From: "Hannah Flynn" <hannah@northpointplanning.com.au>
Sent: Fri, 19 Jun 2026 14:58:25 +1000
To: "Kate Wilkes" <Kate.Wilkes@townsville.qld.gov.au>
Cc: "Meredith Hutton" <meredith@northpointplanning.com.au>; "Development Assessment" <developmentassessment@townsville.qld.gov.au>
Subject: NP25.336 I MCU26/0037 - IR Response - 52 Gregory Street, North Ward
Attachments: ONP25.336 - IR Response.pdf

Response to Information Request

Development Application for Material Change of Use – Short-term Accommodation (100 Rooms) & Food and Drink Outlet located at 52 Gregory Street & 55 Mitchell Street, North Ward and formally identified as Lot 1 on RP 718777 & Lot 2 on RP 718777

Information Request

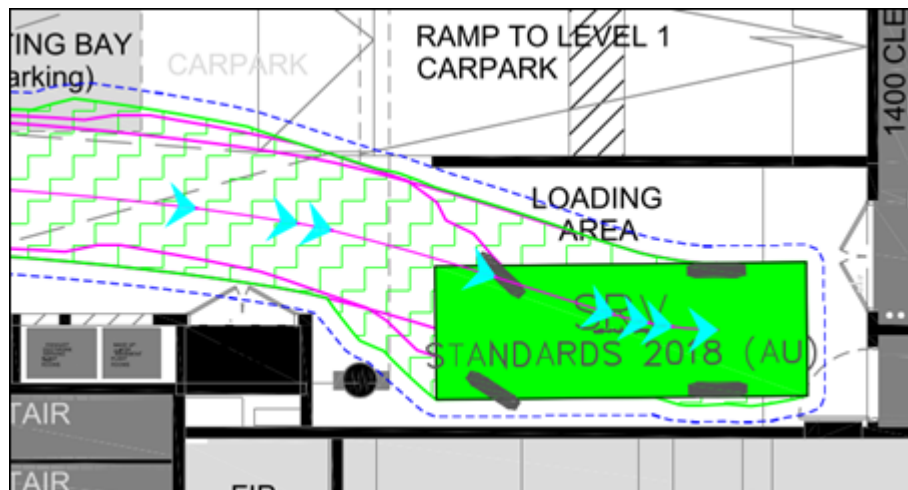
- D. Ground Level Waiting Bay for Single Lane Ramp
- (a) Relocate the after-hours gate further into the site, such that a vehicle waiting for the gate to open can sit within the ramp waiting space and not be required to wait within the street or footpath.

- (b) Revise the layout so that the marked waiting area/stop bar corresponds with the waiting space location assumed in the swept path diagram, and preferably supply additional manoeuvring area to minimise the likelihood of an exiting vehicle hitting the end of the adjoining loading area wall:

In response, amended architectural plans have been provided in **Appendix 2**. It is considered that these amendments sufficiently address Council's concerns regarding the proposed development.

LEVEL 02
TOWNSVILLE HOTEL | 55 MITCHELL STREET +
52 GREGORY STREET

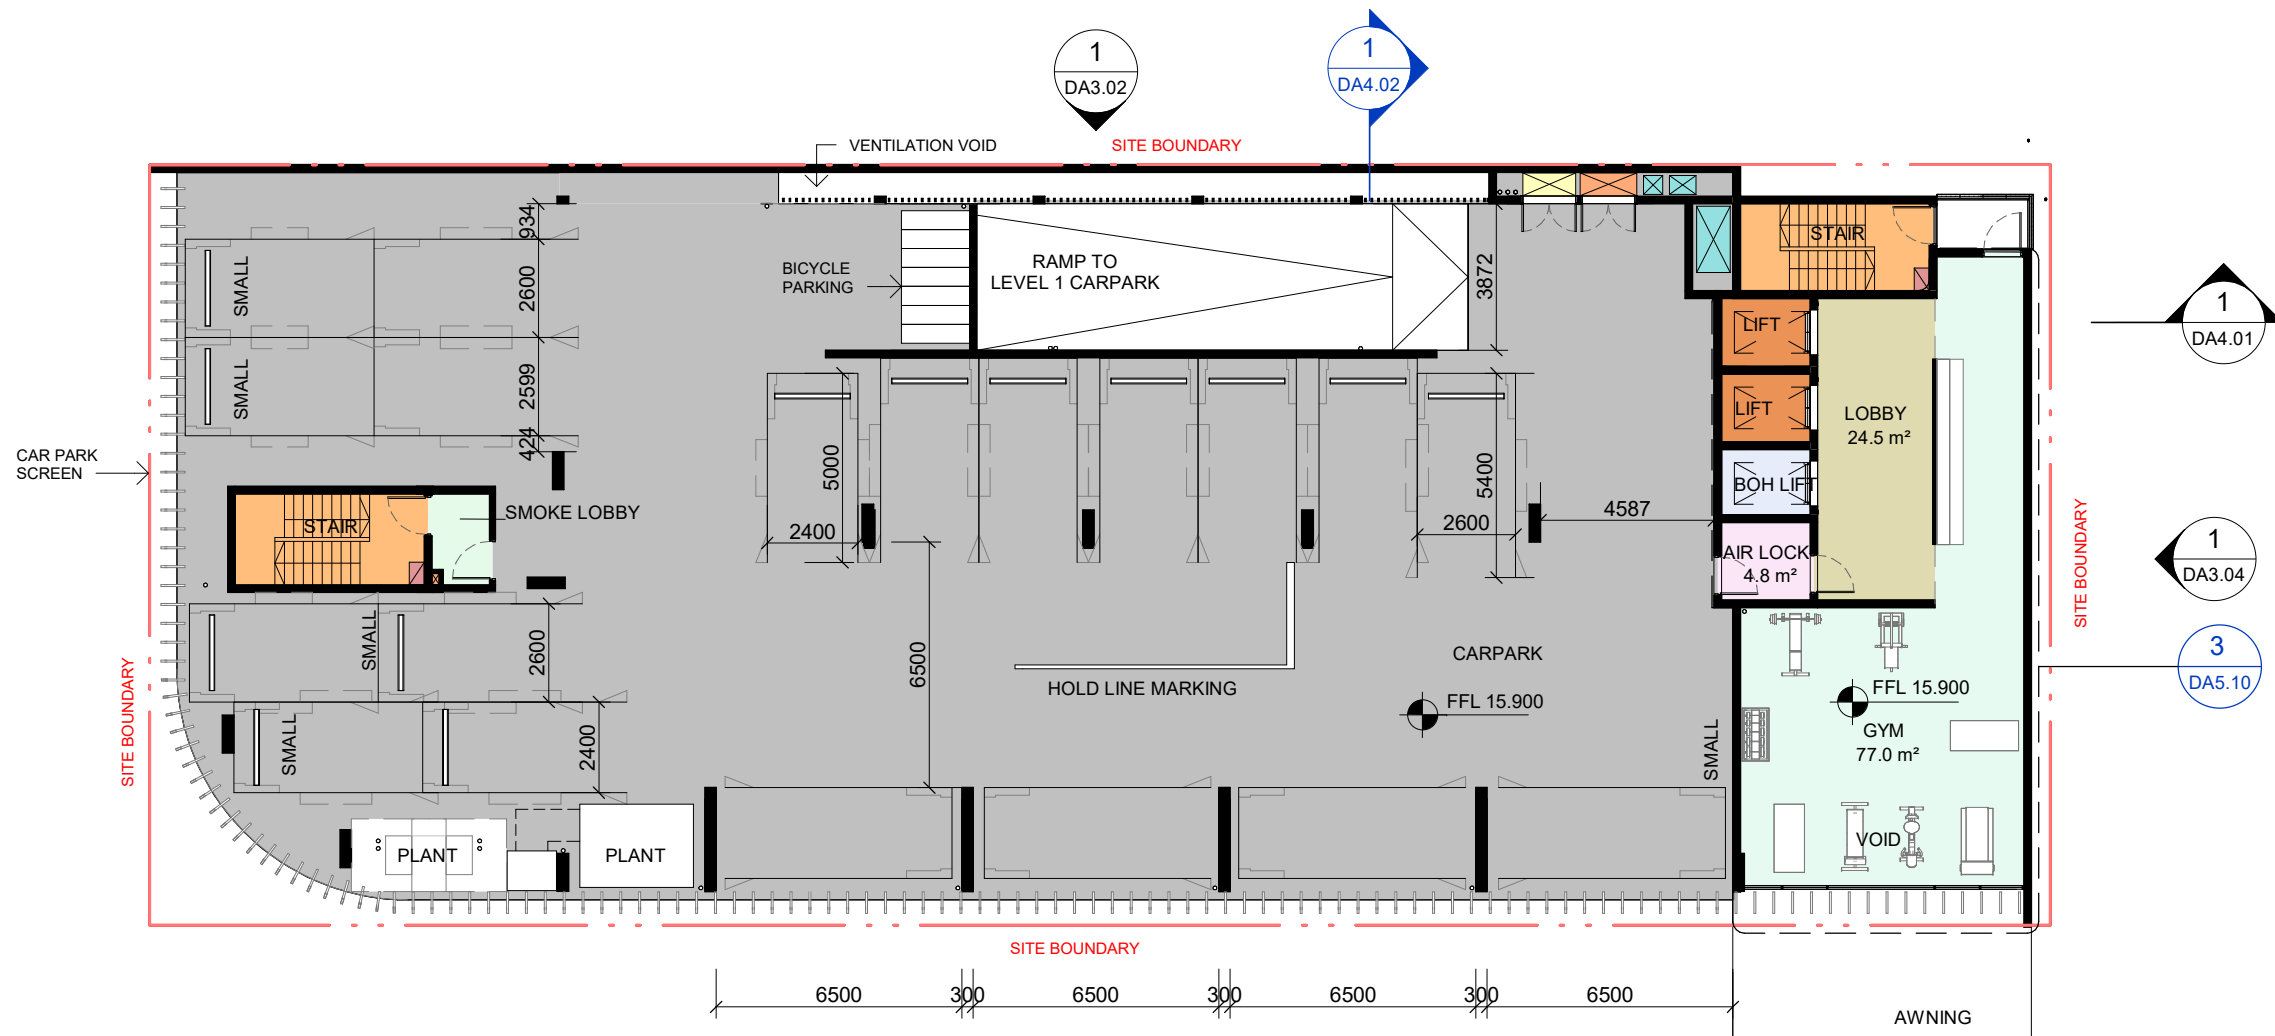
- A. On-Site Car Parking Space Sizing and Configuration
 - (a) Revise to eliminate and/or substantially reduce the small and tandem parking spaces proposed, as these are only suitable for staff and not accommodation guests (noting that the current proposal has 20 guest suitable spaces and 14 staff suitable spaces).
 - (b) Remove all tandem parking from Level 01, as the required tandem parking space manoeuvring conflicts with the through traffic driving between the ground level and parking on Level 02.

- B. On-Site Car Parking Space Quantity
- (a) Revise to provide additional justification for reductions in Policy recommended on-site parking quantity, in particular given that current plans supply only 20 guest suitable spaces and the loss of 14 existing on-site parking spaces), versus 132 spaces (or 25 spaces if the CBD 1 per 4 room rate were to be applied).

The proposed parking area will operate as a managed facility under the day-to-day supervision of hotel staff. Vehicles will be parked and retrieved by hotel staff rather than guests directly. This operational approach is consistent with standard practice for short-term accommodation uses of this nature and scale. Accordingly, concerns regarding tandem configurations and small space

The proposed development provides 34 on-site car parking spaces across Levels 1 and 2. As noted in the Development Application, the practical parking demand for the short-term accommodation component, assessed at the commonly applied CBD rate of one space per four rooms, is 25 spaces. The proposed 34 spaces therefore exceed the anticipated operational demand for the accommodation use.
